**ADDENDUM  
NO. 1**

**March 17, 2025**

**PORTER LAKES ELEMENTARY SCHOOL  
ADDITION, RENOVATIONS, AND RELATED WORK  
Hebron, IN 46341**

This Addendum consists of Pages ADD 1-1, Specification Section 00 34 10 – Responsible Bidding Practices, and attached Addendum No. 1 from Gibraltar Design, Inc. dated March 14, 2025 and consisting of 6 pages, Specification Section 07 41 13 – Aluminum Roofing and 28 drawings.

A501 1 1/2" = 1'-0"

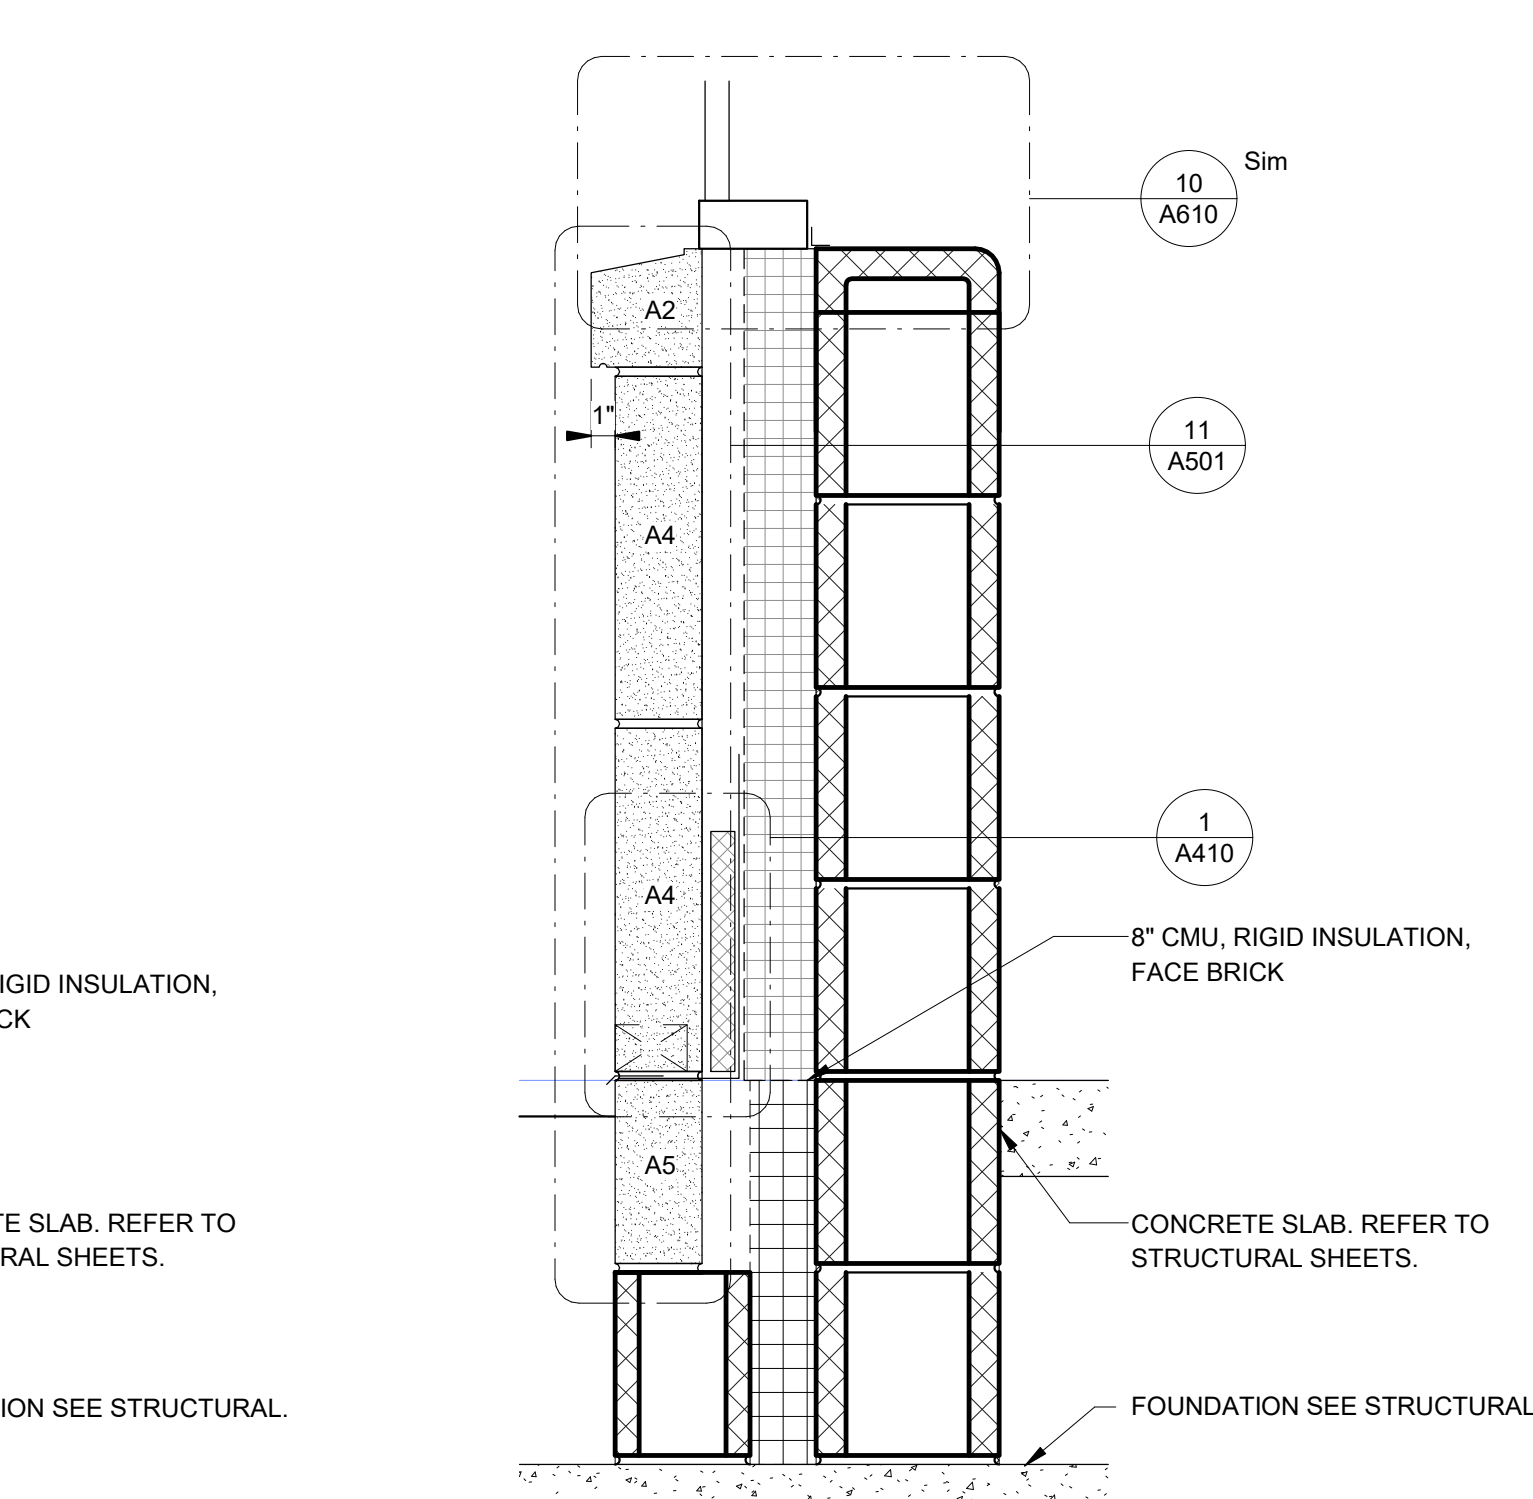
- A. Refer to revised, full-size drawing, included in this Addendum, for revisions.
  - 1. Detail 3 removed
  - 2. Detail 9 renumbered to detail 3
  - 3. Detail 5 modified for insulation and galvanized angle.
  - 4. Detail 6-8 includes cut stone type marks, and are retitled for location clarification.
  - 5. Detail 9 new section at new courtyard windows
  - 6. Detail 10 includes cut stone type mark A3
  - 7. Detail 11 includes cut stone type numbers and additional stone pieces.
  - 8. Detail 12 was added

**P-301**

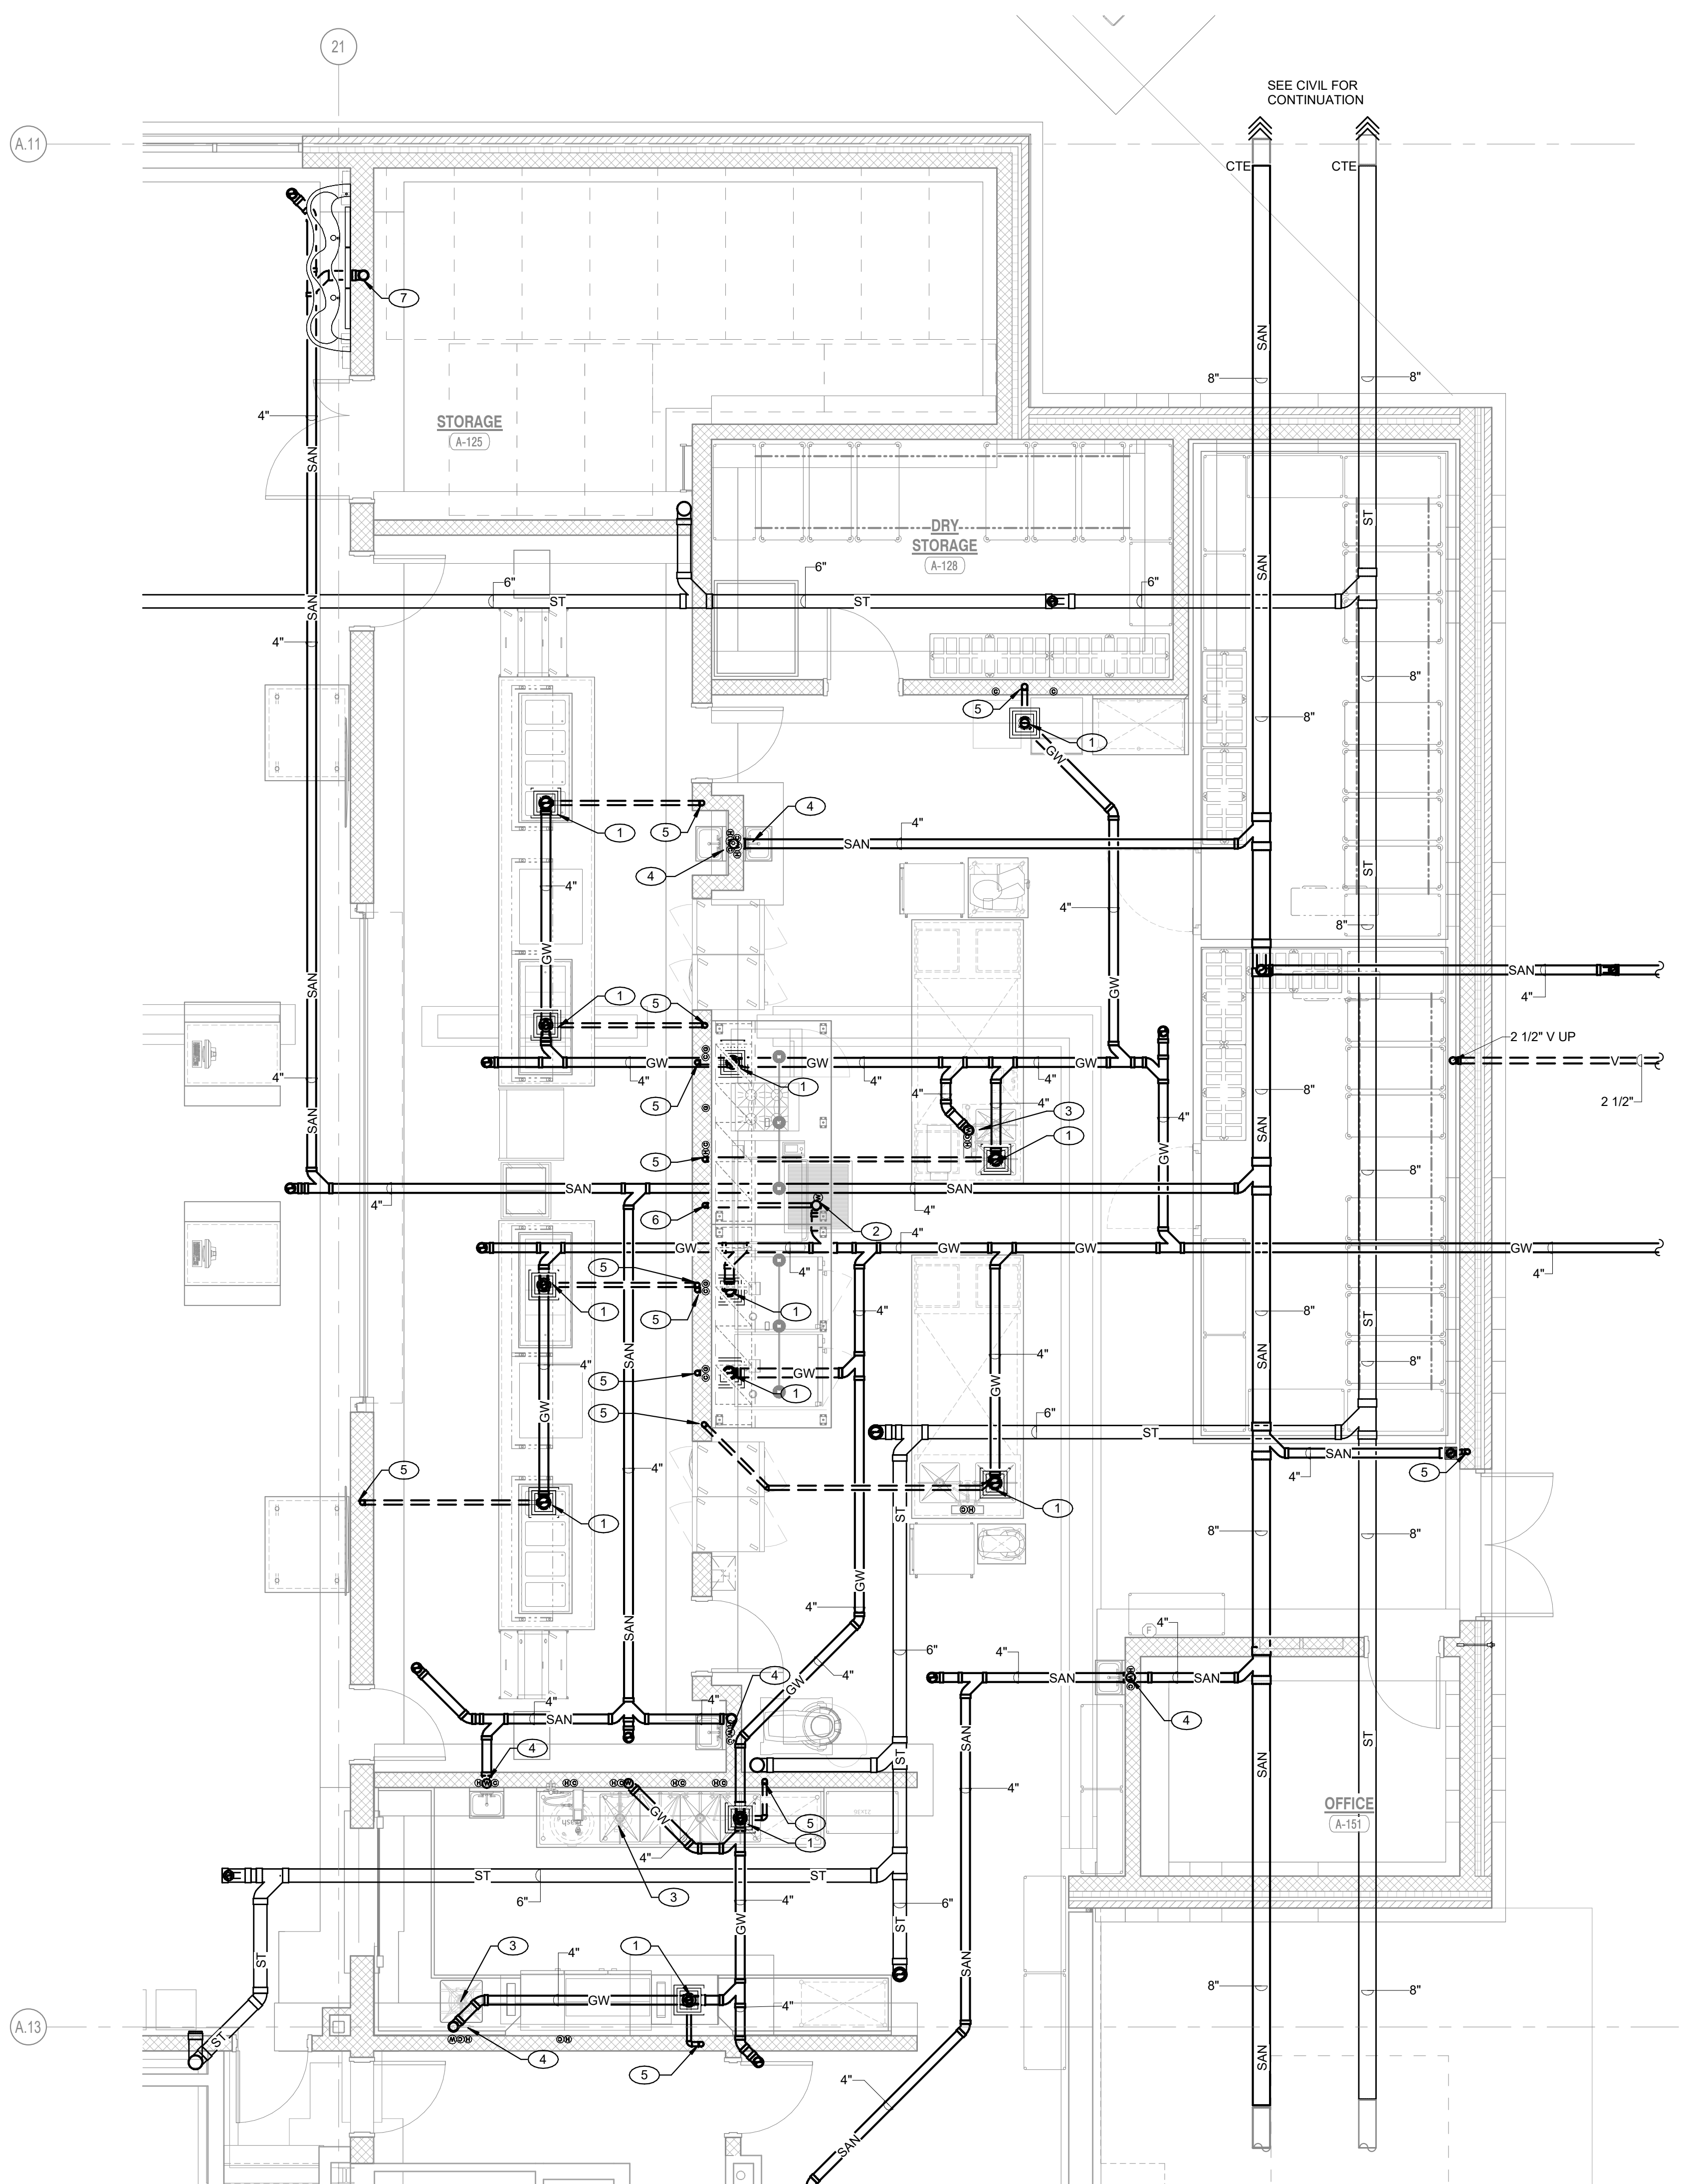
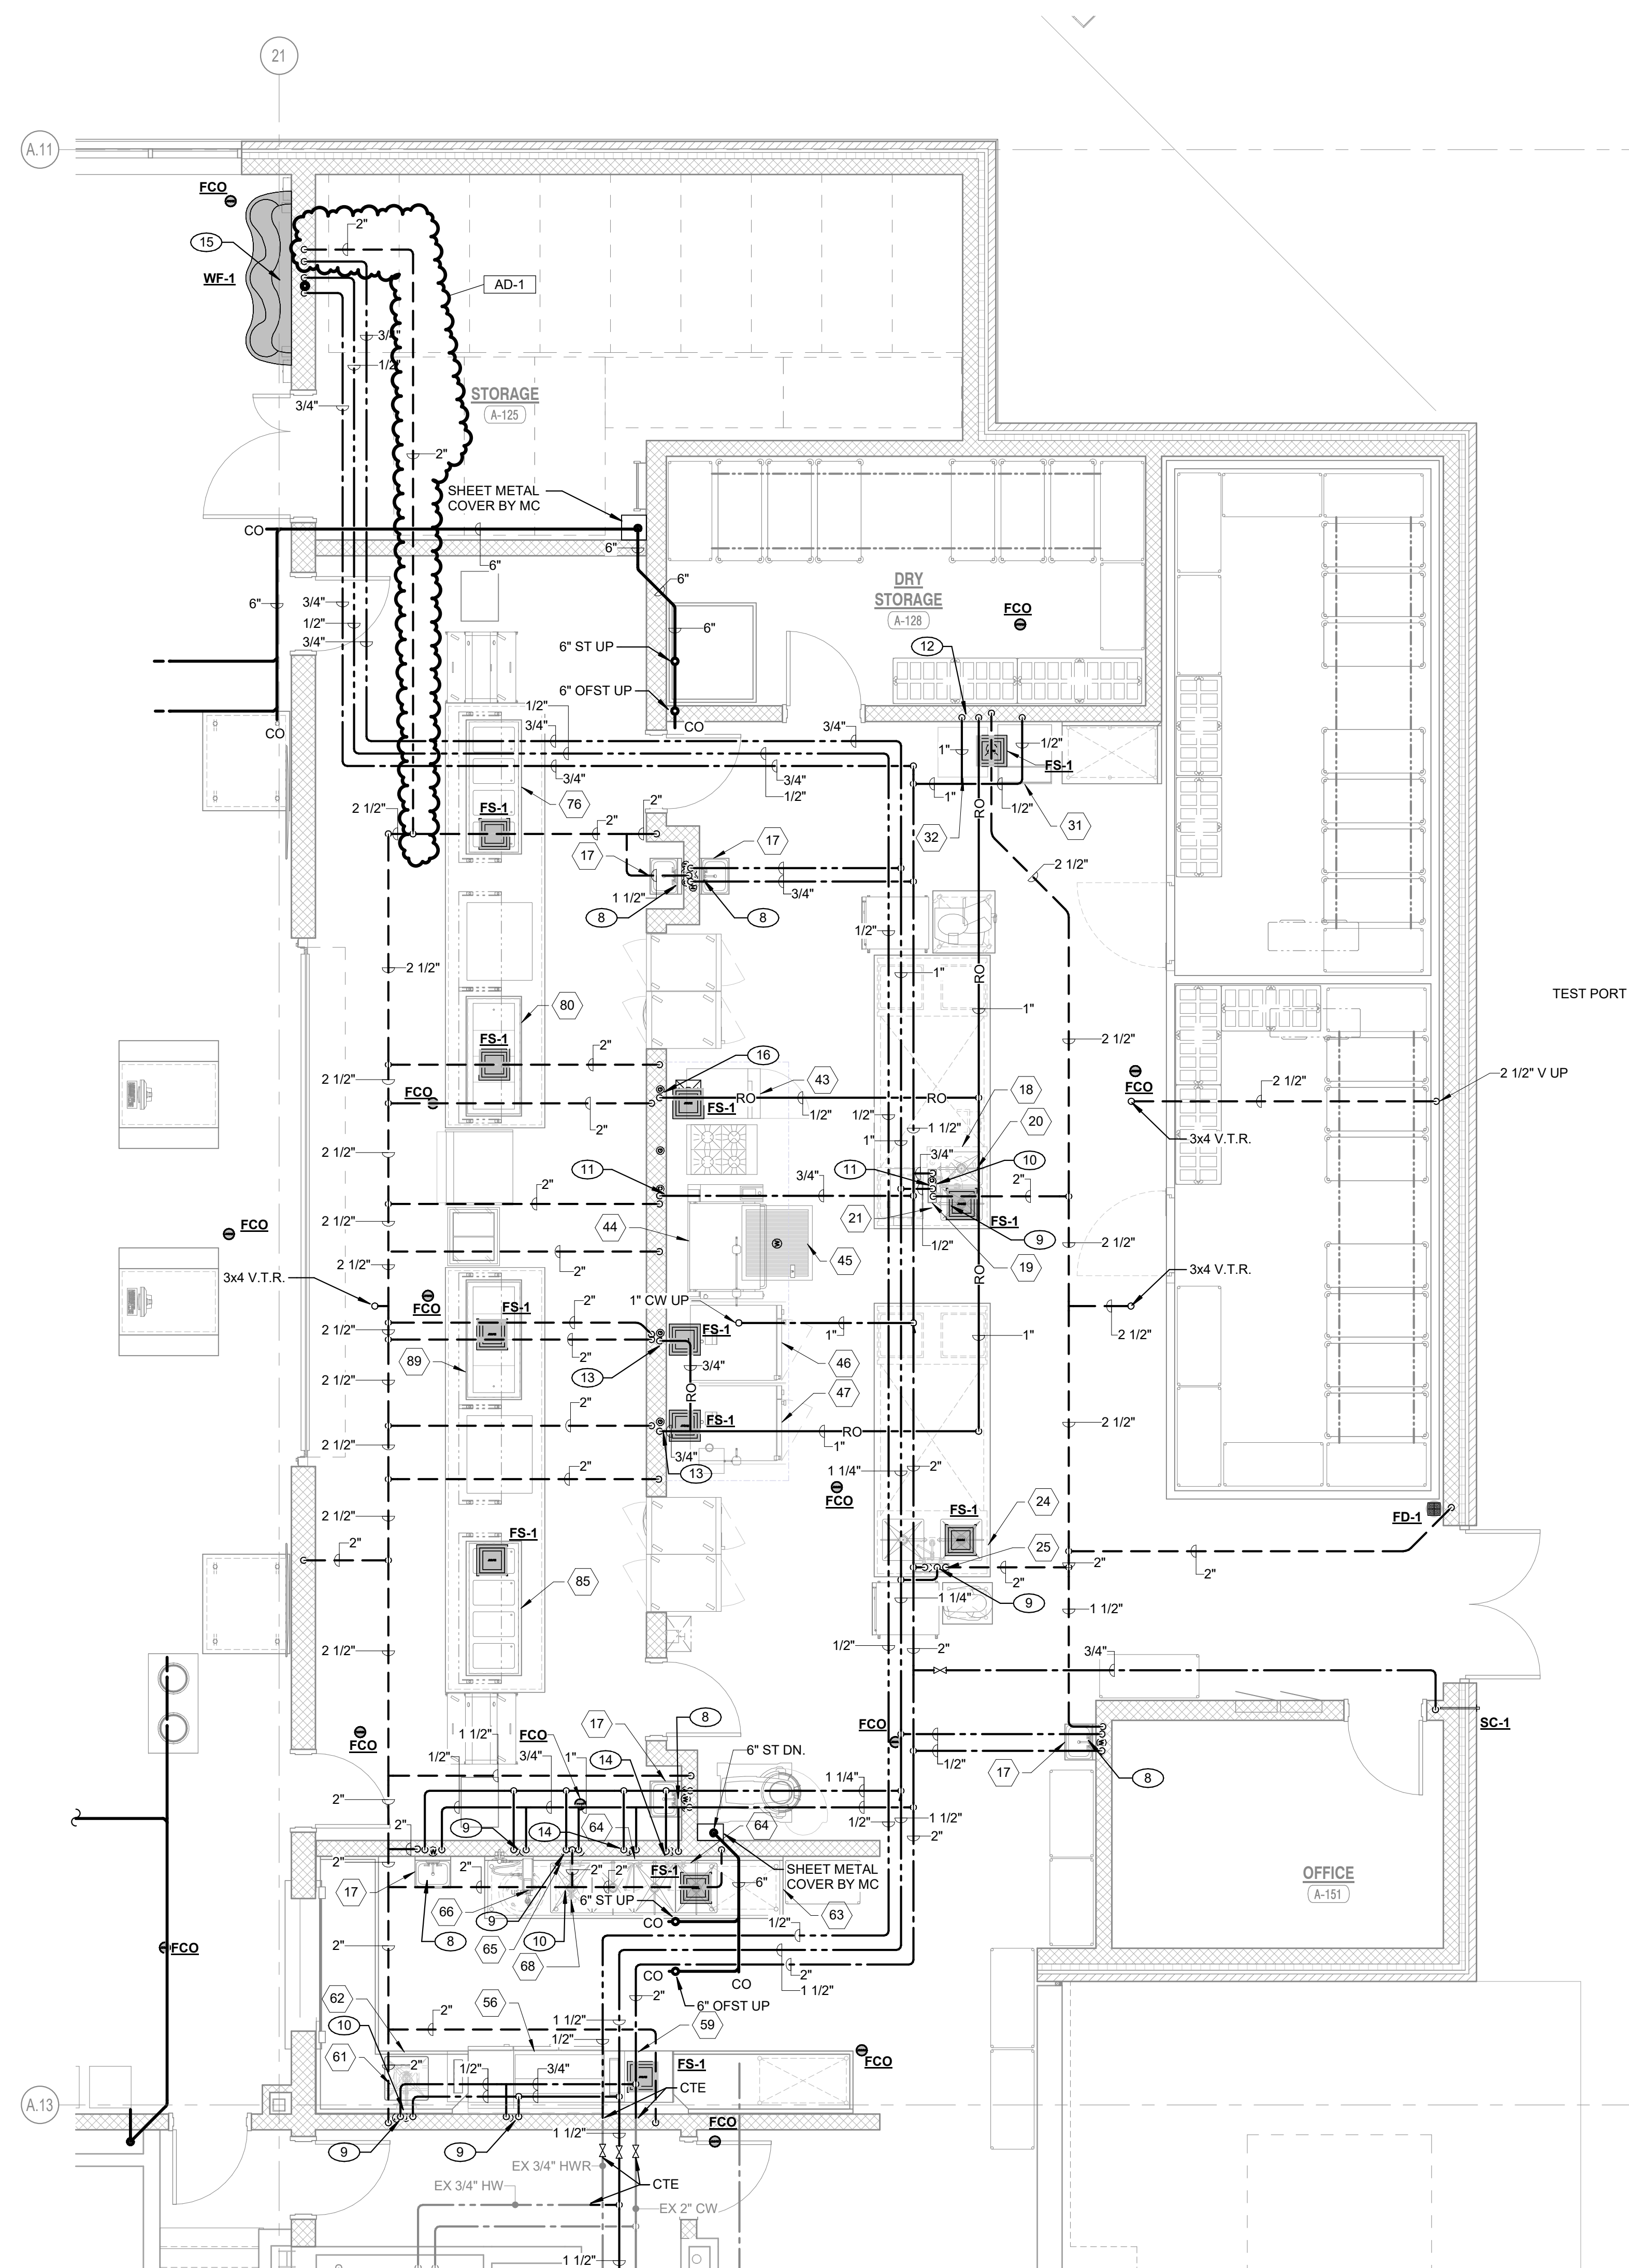
- A. Refer to revised, full-size drawing, included in this Addendum, for revisions.
  - 1. Added vent piping for wash fountain.
